Staff Report to the Western Weber Planning Commission

Application Request: Consideration and action on a request for preliminary approval of Henry Flats Cluster Subdivision consisting of 12 lots, located at 4300 West 400 South

Agenda Date: Tuesday, October 13, 2015

File Number: LVH051914

Henry Flats Cluster Subdivision

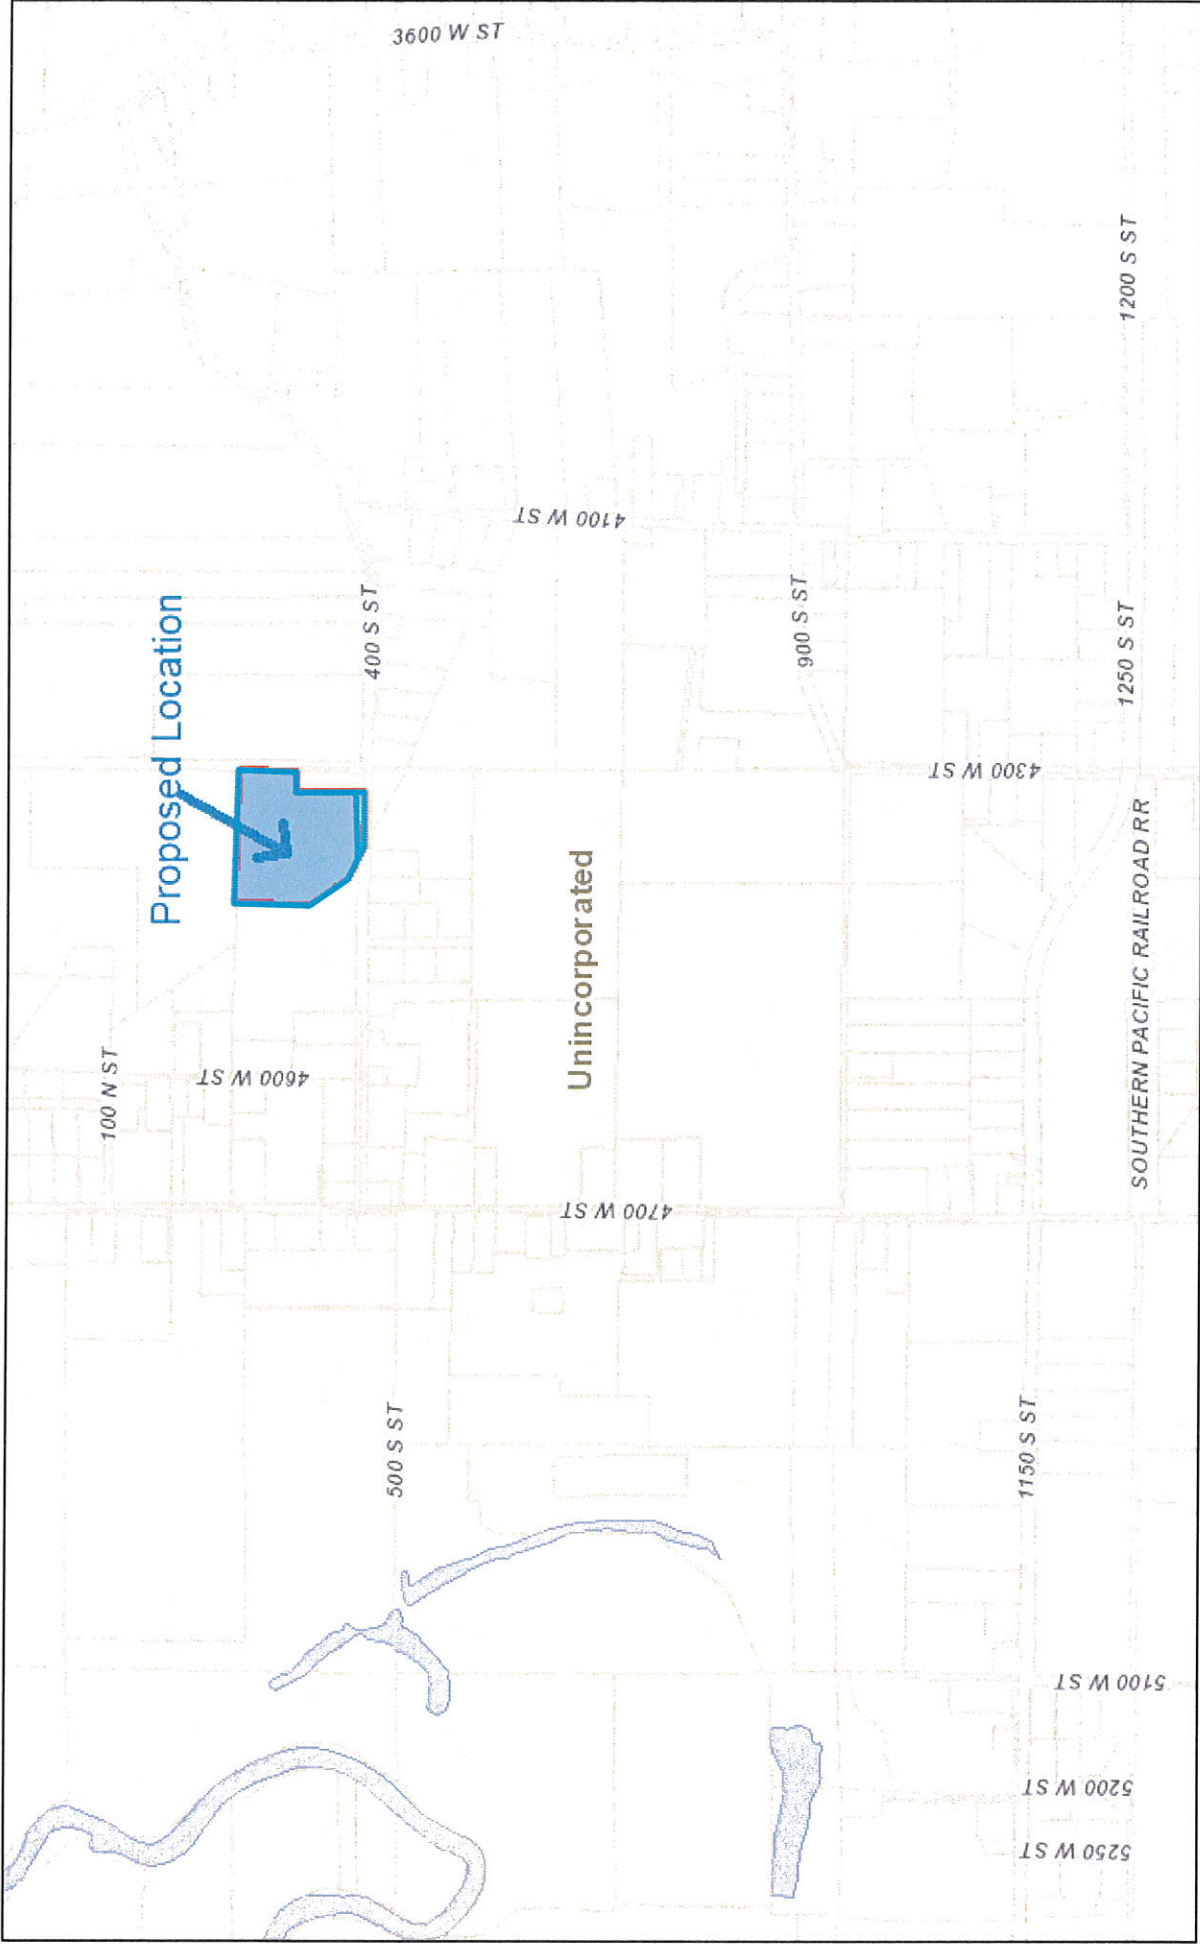
- Provide details and location of the secondary water pond and the delivery system.
A new secondary water pond is being shown on lot 11 along the rear property line. The water will be pressurized with a 6 inch lateral to each of the lots.
- Redesign the subdivision removing the property that is not owned by the developer, show proof the property is now owned by the developer, or provide a signed and notarized letter from all the property owners that the property is to be sold to the developer.

Culinary water will be provided by Taylor West Weber with the developer creating a pond for irrigation water. A water capacity assessment letter needs to be provided prior to final approval. The applicant has Hooper Irrigation water shares. There is still a question as to where the secondary water pond will be located. This information should be presented to the Planning Commission.

The County Engineering Division wants the ditch in the front of the property to be piped. If the curb, gutter, and sidewalk are deferred, then the grade will need to be brought up to within a foot or less below the edge of asphalt. A note will need to be added to the plat stating: "Due to the topography and the location of this subdivision all owners will accept responsibility for any storm water runoff from the road adjacent to this property until curb and gutter is installed. A Storm Water Pollution Prevention Plan (SWPPP) is required to be submitted for all new development where construction is required. A Storm Water Construction Activity Permit is required for any construction that:

Wastewater treatment will be provided by individual septic systems. The original subdivision plat that was submitted had 13 lots. After a year of water monitoring and working with the Health Department, the Health Department has approved the subdivision for 12 lots with the condition that lots 7-12 are approved for a 3 bedroom home. A note on the plat and a covenant that is recorded as part of this subdivision needs to indicate this requirement. The reason for the limitation is because of the irrigation ditch on the rear of the lots.

The Weber Fire District has reviewed and approved the fire hydrant location. The applicant is asking for a deferral of curb, gutter, and sidewalk. However, since the lots are below 40,000 square feet, should curb, gutter, and sidewalk be required? The review from the Weber School District states "elementary students are not eligible for bussing to West Weber Elementary site".

Staff recommends preliminary approval of Henry Flats Subdivision with 12 lots, subject to staff and agency requirements, with the requirement for curb, gutter, and sidewalk, as this subdivision is within walking distance to West Weber Elementary School, the lots are smaller than an acre in size, and the students are not eligible for bussing.
